2013 Space Human Factors Engineering Standing Review Panel Status Review

Comments to the Human Research Program, Chief Scientist

Subject: Response to NASA on Questions on 1/14/14 SHFE SRP Report

HRP 2013 10

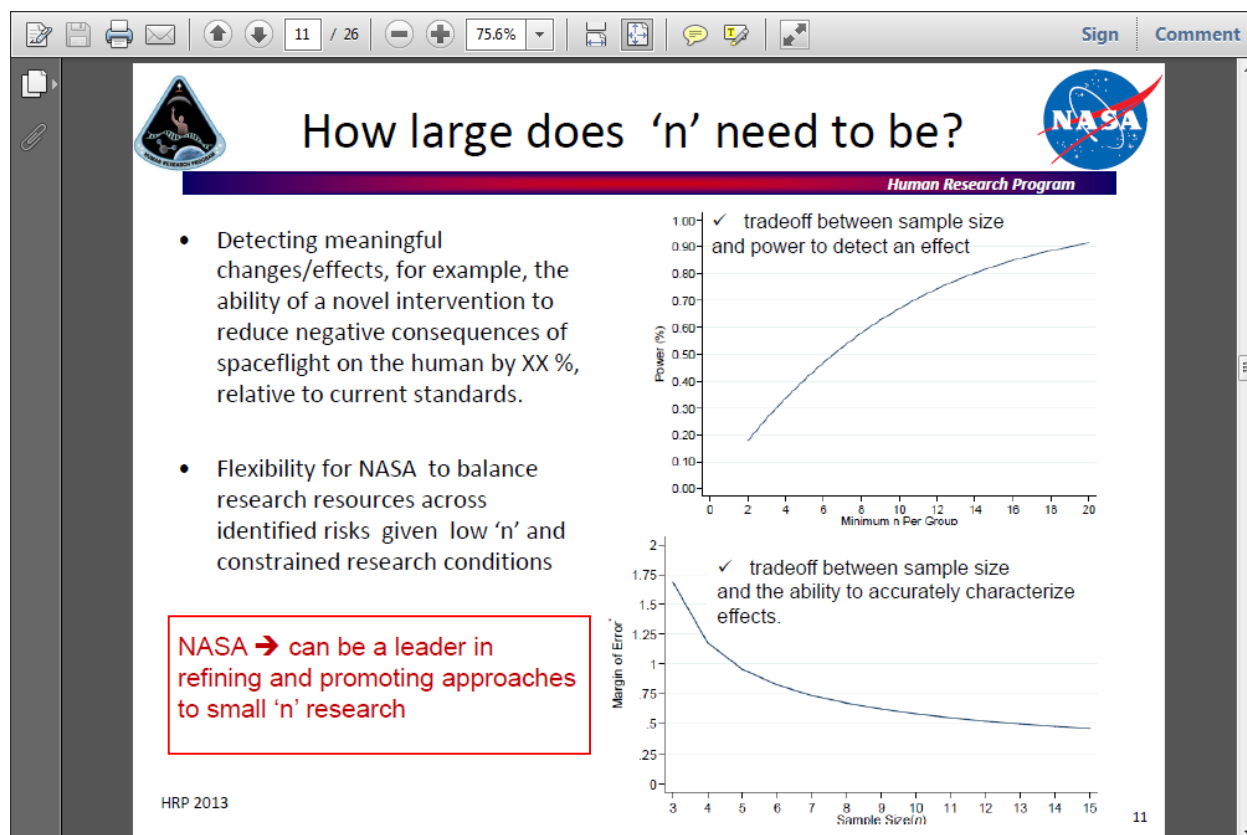
NASA has commented back to the SRP that we may have misunderstood or made errors in our comments on the content of their presentation on small n and twins research. They have said there is basically no research being conducted where $n=1$, and no twins study.

Below are thumbnails of slides 10 and 11 that Dr. Shelhamer presented on 12/4/13. Highlighted in red are the portions that say $n=1$ is important and NASA seeks to be a leader in small n research.

Furthermore, we assumed that the ISS mission referred to is the mission where twin astronauts will be used, one on the ground and one on the ISS, and comparisons of fine motor activity will be made; one of us was asked to review the proposal for this study earlier in 2013. Such a comparison in a within-subjects or paired t-test design is considered $n=1$ (1 matched pair), as the difference between the scores of the two participants would be the data analyzed. It is understood that a cosmonaut will also be aboard ISS, but that his participation was not assured. In any case, if he does participate, he would only be part of a matched pair with the ground astronaut, which would result in $n=2$, which is not much better statistically than $n=1$ for obtaining statistical power in inference testing. This is assuming it is valid for the ground astronaut to act as a control for both ISS astronauts.

Since the time of the meeting, one of us had the opportunity to discuss the small $n/n=1, 2$ or 3 / twin experimental scenario with two biostatisticians who attended the Habitation research proposal review panel in Washington, DC in March 2014. Both statisticians were skeptical that any inferential statistics could be validly and reliably performed on one matched pair. When asked what kind of statistics could be performed in such a situation, one said, “none” and the other said “descriptive statistics;” in other words, frequency plots, ranges, not inferential statistics. So hypothesis testing with statistical verification wouldn’t really be appropriate.
